# Triumph

CRANKSHAFT SPIGOT BUSH SQUEAL

TR7

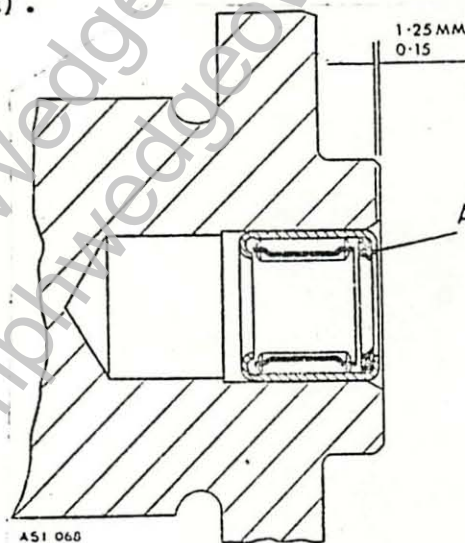
In the event that a TR7 owner should complain of a squealing noise emanating from the spigot bush in the rear of the crankshaft on 1975 and 1976 TR7s, this can be overcome by the installation of a needle roller bearing, part #UKC-8154 in place of the bronze spigot bush. (Refer to diagram).

1. Remove the gearbox.
2. Remove the clutch assembly.
3. Remove the 8 flywheel retaining bolts.
4. Remove the spigot bush retaining plate and discard.
5. Withdraw the spigot bush and discard.
6. Insert needle roller bearing, part #UKC-8154, with the integral seal A (refer to illustration) facing the gearbox side. The needle roller bearing is to be pressed into the crankshaft to the dimension shown in diagram.
